Rezoning Transportation Analysis

Petition Number: 2023-039

Revision Log:

Transportation Summary

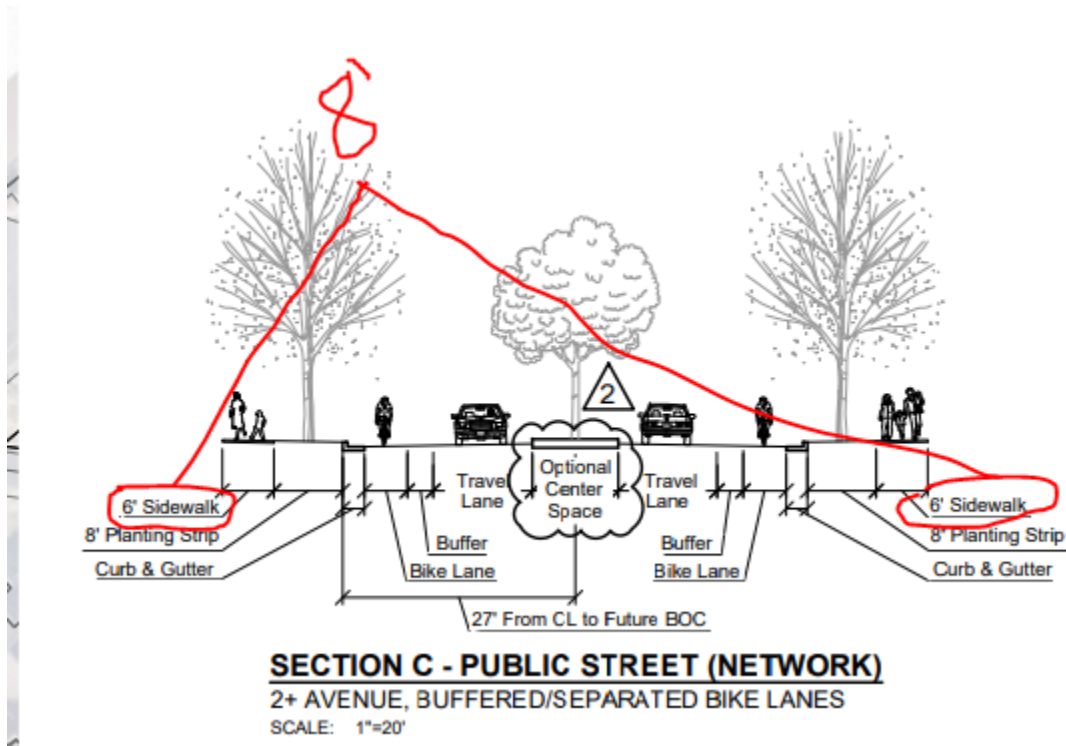
~~New Comment 11.27.23:~~ Section C public street network sidewalk width does not match the conditional note. Revise Section C to have an 8' sidewalk like the conditional notes for the Old Providence Road section.

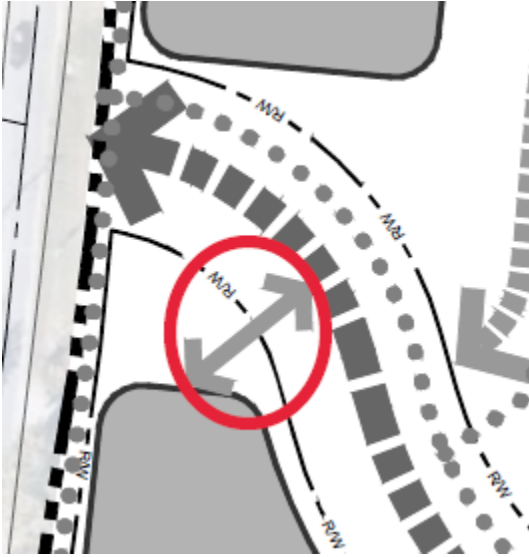
16. **New Comment 2.21.24:** Fix alignment at intersection circled below and ensure that there is at least 50' of separation between horizontal curves.
